# Town of Hilton Head Island Regular Design Review Board Meeting

January 12, 2016

## AGENDA

1 FRONT ELEVATION (NORTH)  
 A2.3b SCALE 1/8" = 1'-0"

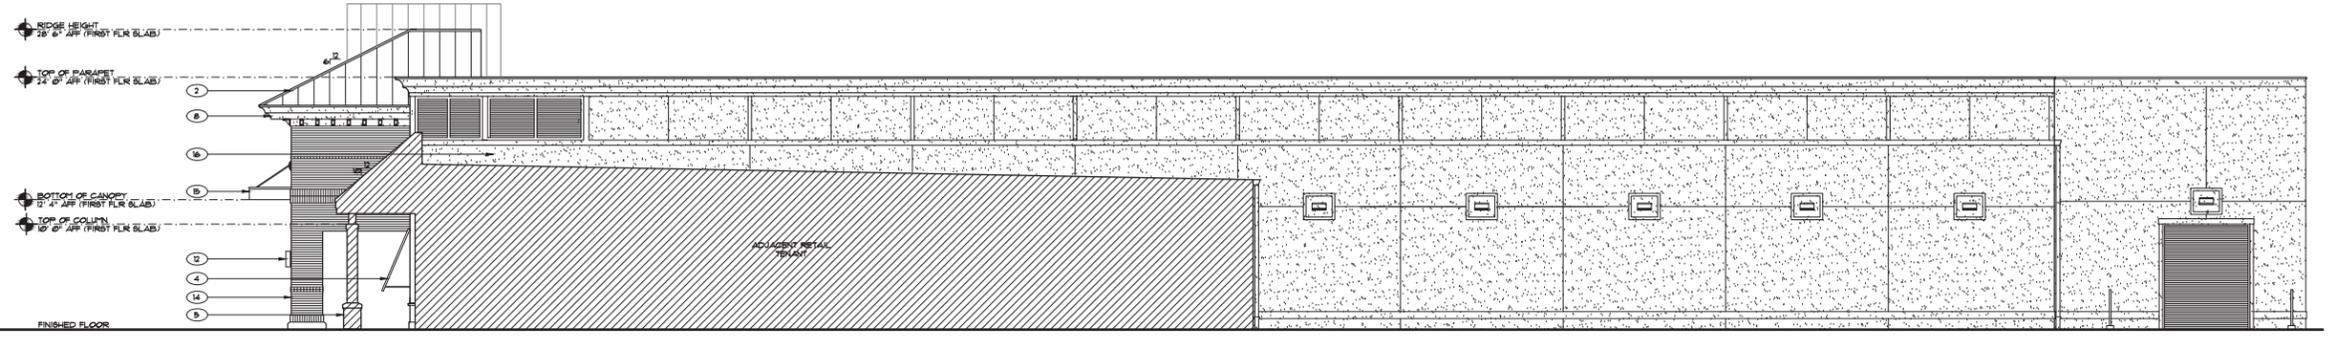
**-Comment #5:** Re-study roof line at Retail Shop between Junior Anchor #1 and #2.

- a. The retail shop was pulled forward in plan to align with Jr. Jr. Anchor #2. This allows for the sloped roof line of the covered entry for the Retail Shop to continue along the front façade of Jr. Anchor #2 and transition to trellis which also occurs on the Steinmart front façade.

4 BLDG. F BRICK ENTRY ELEMENT  
 A5.5 SCALE 3/4" = 1'-0"

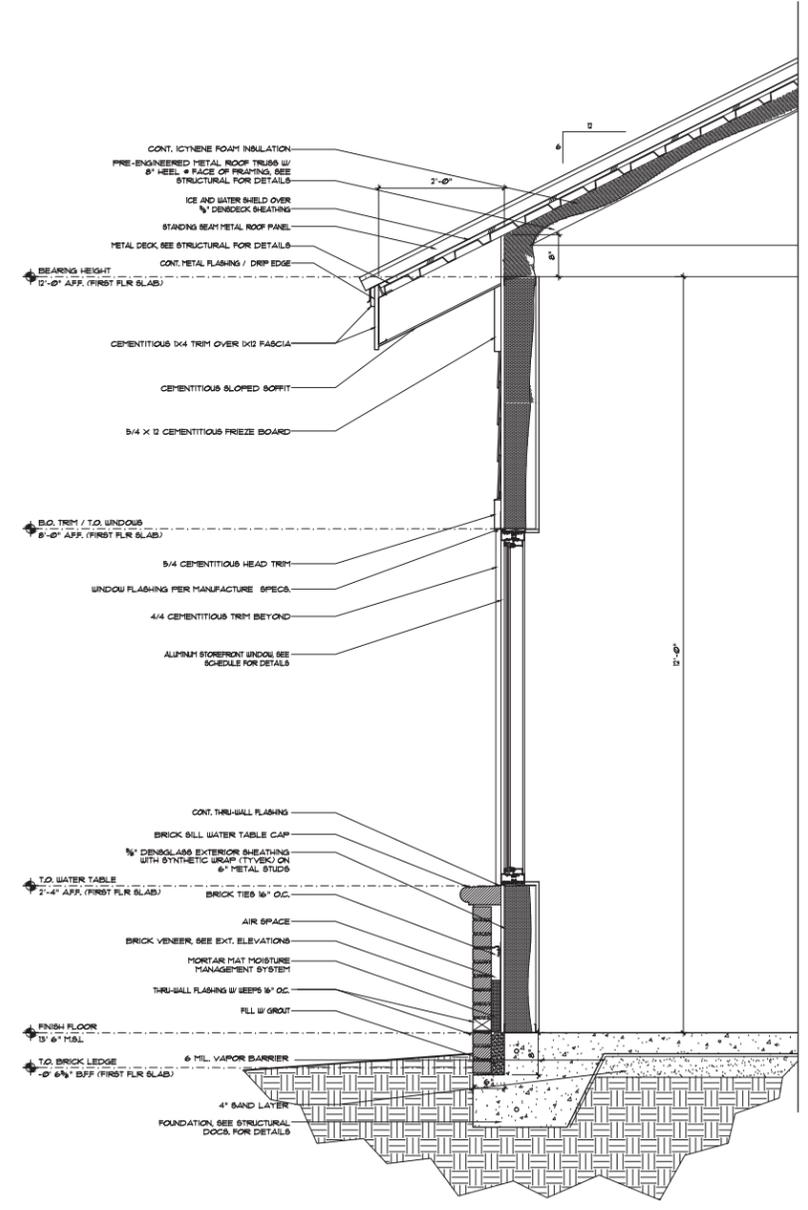
**-Comment #2:** Adjust proportions of brick entry feature and address kitchen exhaust hoods.

- a. The base of the brick entry feature was made wider and height of the feature lowered.
- b. A tabby stucco chimney like feature was added to the roof to house the kitchen exhaust hood and make up air.
